CASE: C814-2023-0057 (200 E. Riverside PUD) DISTRICT: 9

ZONING CHANGE REVIEW SHEET

CASE: C814-2023-0057 (200 E. Riverside PUD) DISTRICT AREA: 9

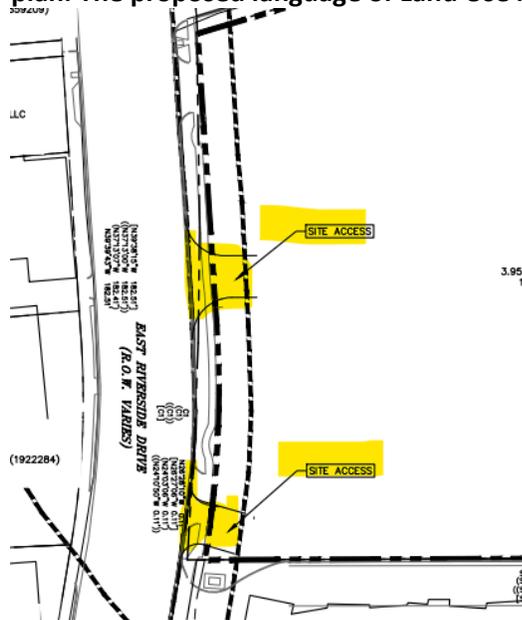
U2: Comment pending. The TIA final memo states the following:

8. Approval of this TIA does not grant nor guarantee approval of proposed driveway locations or driveway types. An updated TIA or addendum may be required at the time of the site plan when more details about the site are available.

Accordingly, please remove any reference to site access points from the PUD exhibits or note that they are only demonstrative and subject to review at the time of site plan. The proposed language of Land Use Note #1 should be modified to reflect this.

Figure 2: Barton Springs Road Extension Cross Sections

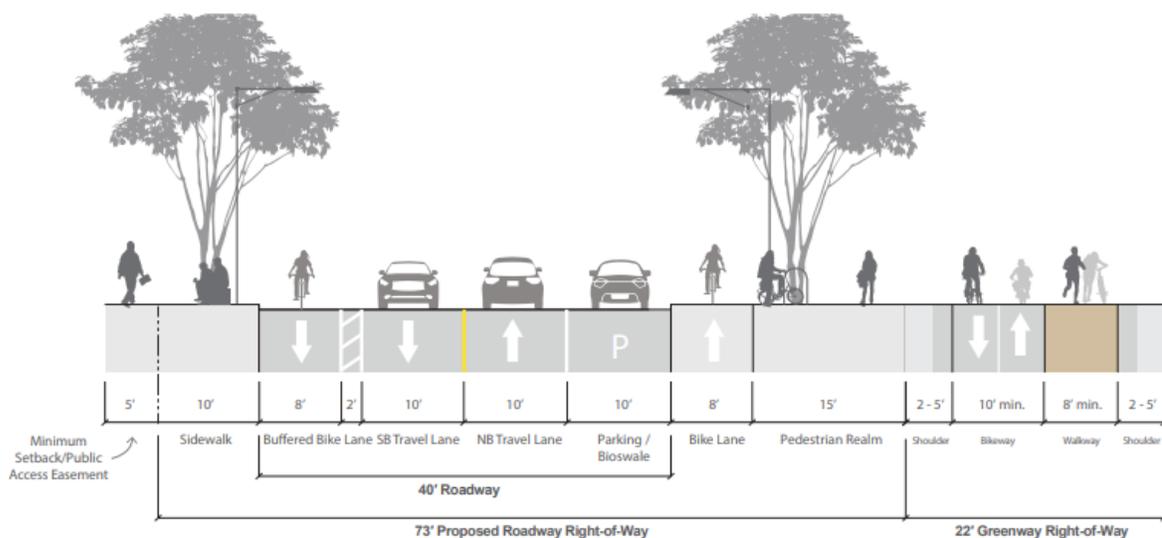
TPW recommends that the PUD specify these improvements by offering deference to the South Central Waterfront Plan, specifically the 22' "greenway" and/or the desired cross-section as identified by Project Connect when available:

- U1: Comment pending TPW comment #6.
- U2: **Comment pending. Land Use Note #24- at this time it is unclear how these “improvements” will be above and beyond the base line requirements of the TCM. Please clarify what these improvements may entail and add the language “subject to approval from Director” to the proposed note.**

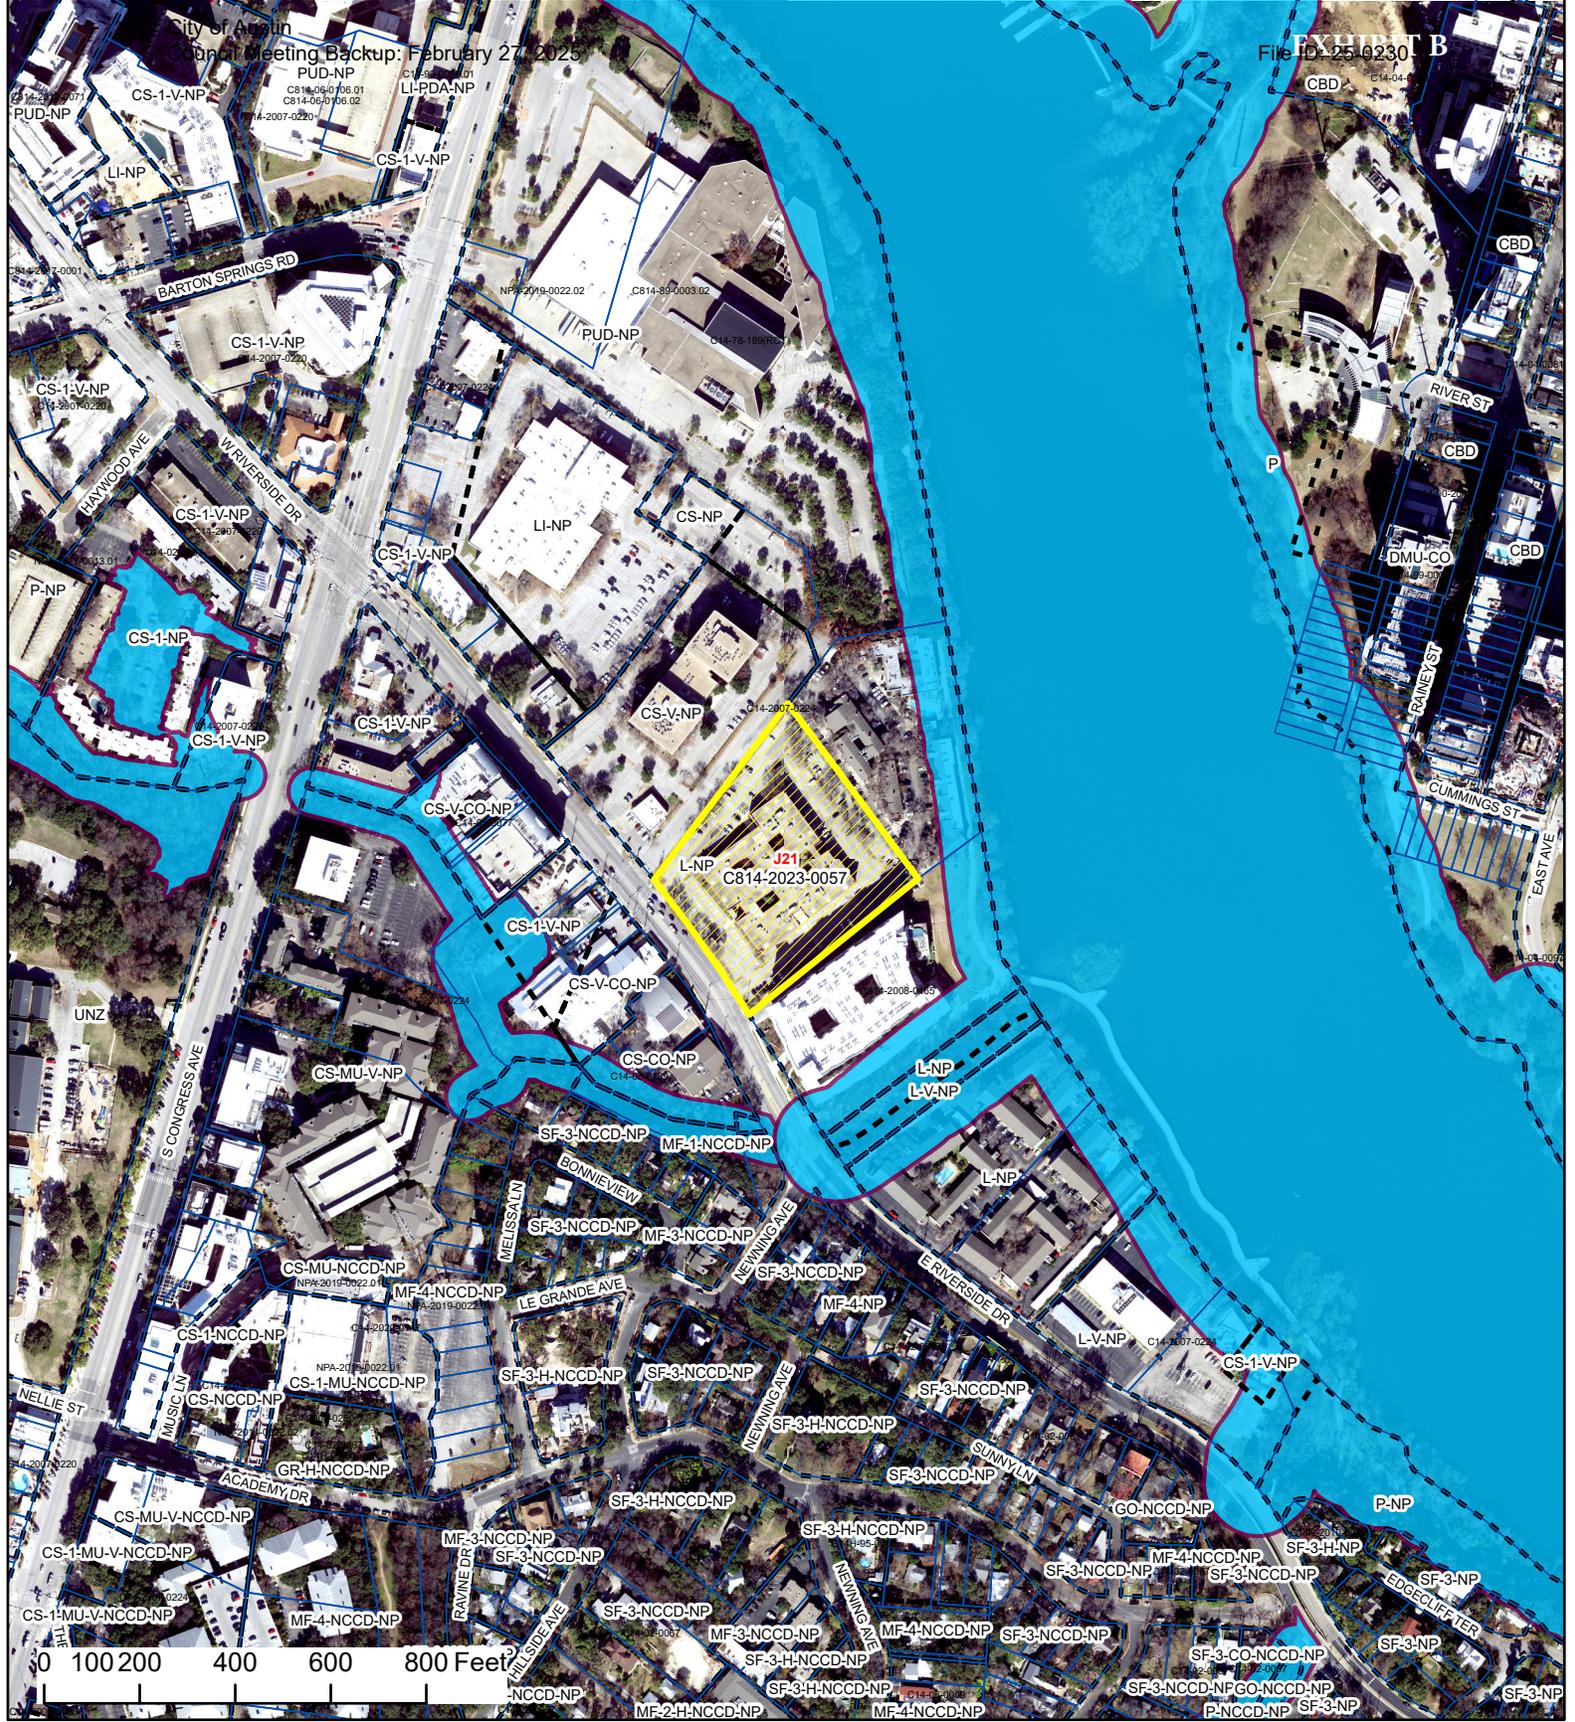
WQ 2. Projects submitted after November 7, 2022, will be required to provide green stormwater control measures to meet water quality control requirements (with some exceptions) in accordance with the recently passed Ordinance No. 20221027-045, Part 18 [25-8-213 (C) and (D)]. Green infrastructure options are outlined in ECM 1.6.7. Administrative waivers may be granted on a case-by-case basis. The ordinance document can be found here (see pg. 24-26 for green infrastructure requirements): <https://services.austintexas.gov/edims/document.cfm?id=399108>.

Per the superiority table provided, green water quality controls as prescribed in ECM 1.6.7 are proposed to treat 50% of the required water quality volume. Please note that the use of green water quality controls as prescribed in the ECM should not be considered superior for the purposes of Tier 2 requirements. Please confirm acknowledgment.

Figure 2. Improvement Extent

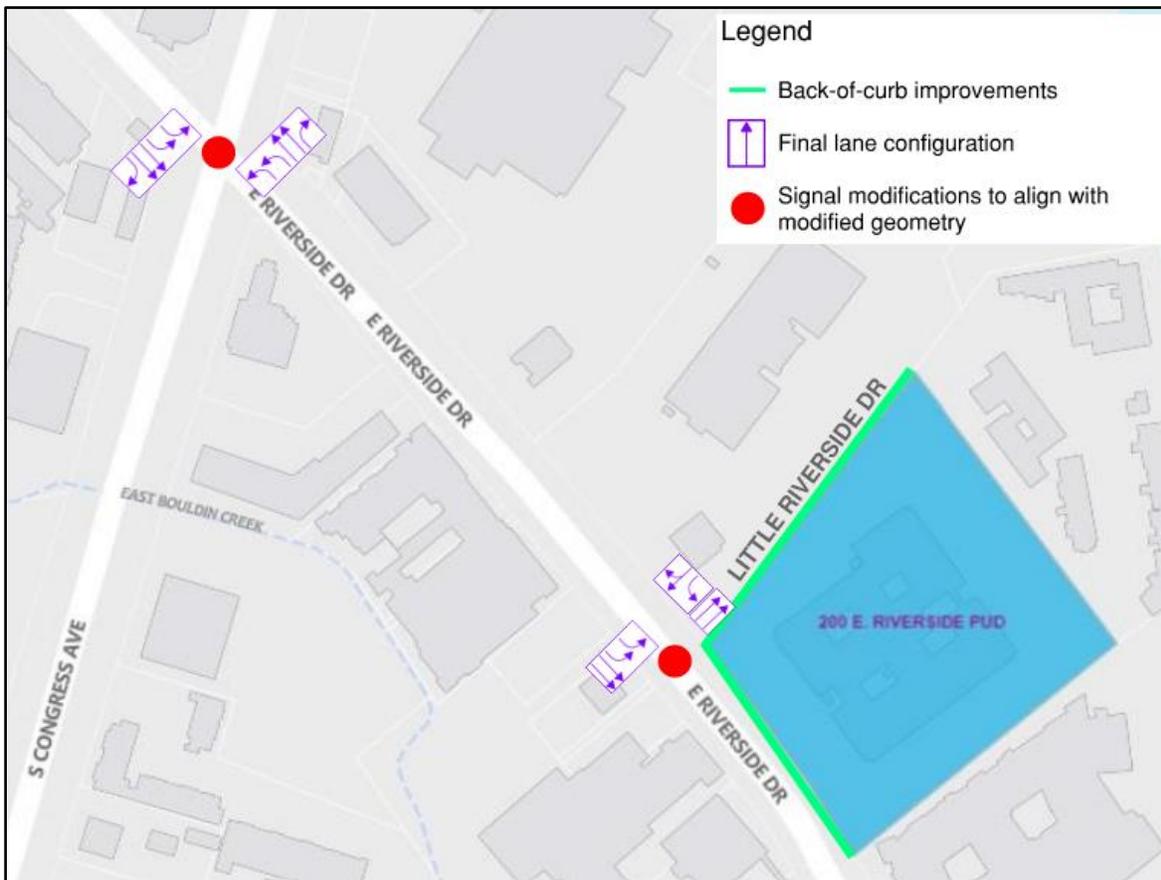
Install 1 RTL along WB E Riverside Dr approach
	Signal re-timing, lane assignment sign, signal head modification as needed to align with modified geometry
Back-of-curb Improvements (See Figure 2 for the improvement extent)	Design and construct back-of-curb improvements with the coordination of TPW along site frontages on Little Riverside Dr & E Riverside Dr
